N1092D-02

Modification Available Performance Enhancement Service Note

N1092D DCA-M Sampling Oscilloscope

An improved extinction ratio calibration is available for DCA-M Sampling Oscilloscopes with option 30A

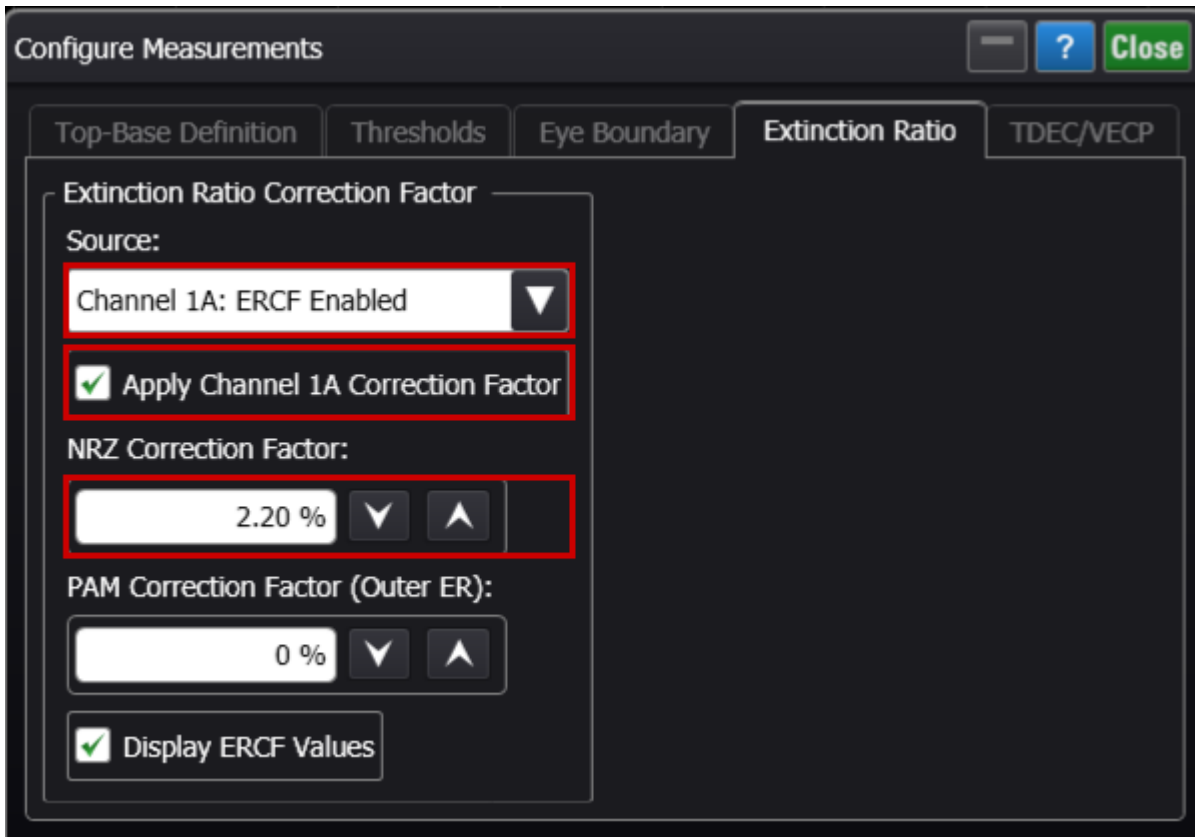
For N1092x DCA-M instruments with option 30A, units with the improved ER calibration are identified in the Help > About dialog with a “C1” annotation following the serial number.

- If the “C1” annotation is present, the unit has the improved ER calibration
- If the “C1” annotation is not present, the unit has the older ER calibration
